SERVICE BULLETIN

THRUSTER EXTENSION AND VORTEX GENERATOR INSTALLATION

* Supersedes Service Bulletin SB900-099 dated 09 May 2006. Revised to change time of compliance and add a note for the installation of new thruster extension fairings. Aircraft that are in compliance with Service Bulletin SB900-099 meet the intent of this revision, please complete and return compliance form.

Figure 1. Fan Felt Seal Identification

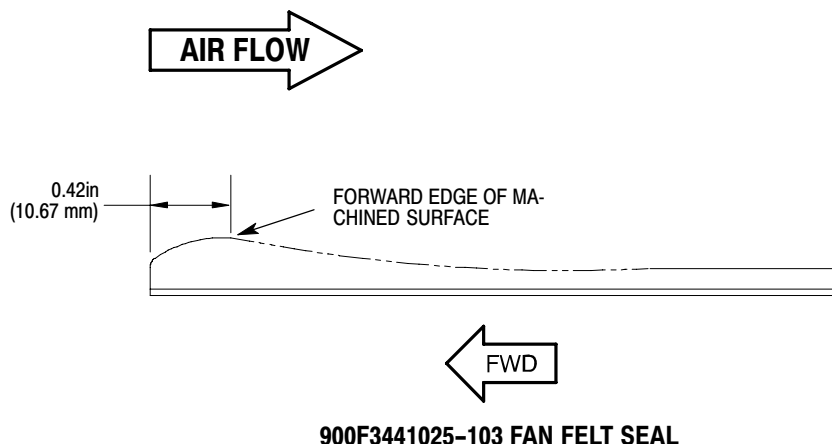
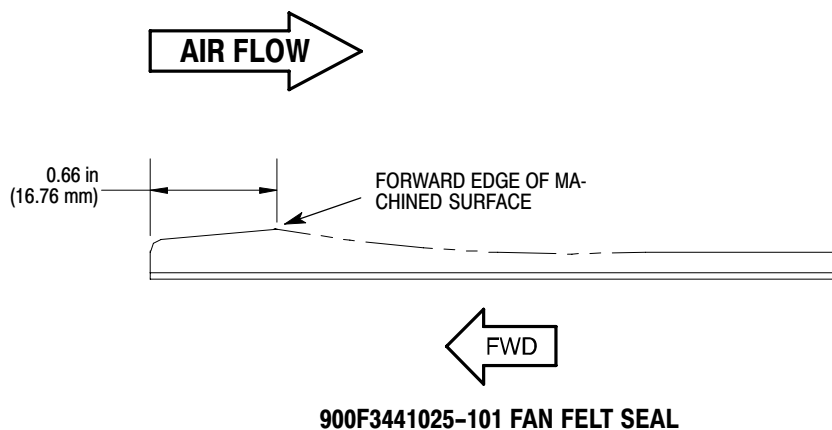
- (1). Verify that P/N 900F3441025-103 NOTAR® Fan Liner (Felt Metal Seal) is installed.
(Ref. Figure 1)
 - (a). If necessary, replace with a P/N 900F3441025-103 Fan Liner (Felt Metal Seal) (Ref. CSP-900RMM-2, Section 64-30-00).

Figure 2. Thruster Extension Modification

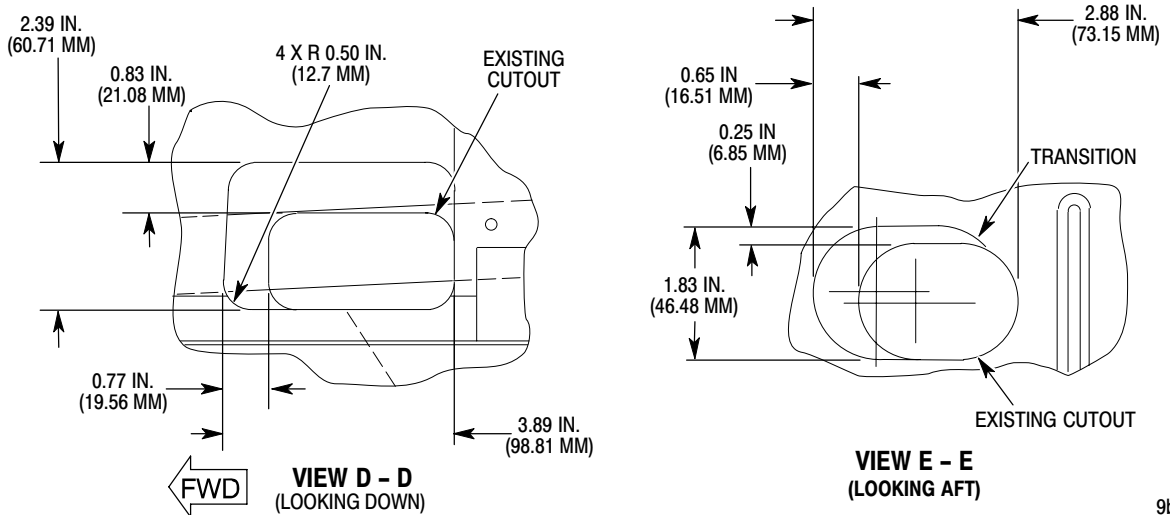
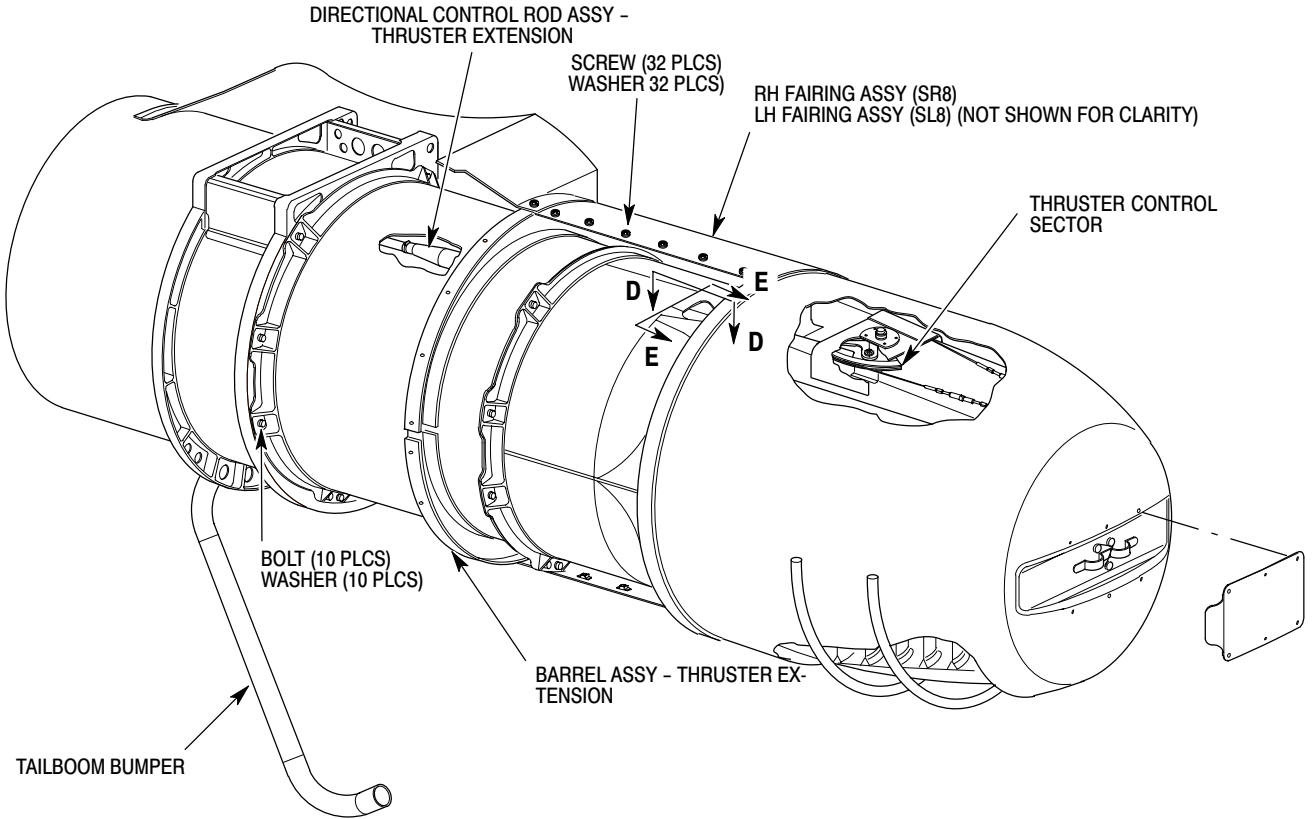
(8). Modify thruster assembly.

- (a). Trim thruster control rod pass thru hole per View D-D and View E-E and seal any exposed fibers with Epoxy Resin, refer to resin manufacturer's instructions.
- (b). Verify that installed thruster control sector assembly is PN 900C2010392-109. If the PN is not correct, contact MDHI Field Service Department.
- (c). Using permanent ink, reidentify modified thruster assembly, at location of existing part number, as PN 90005310000-101.
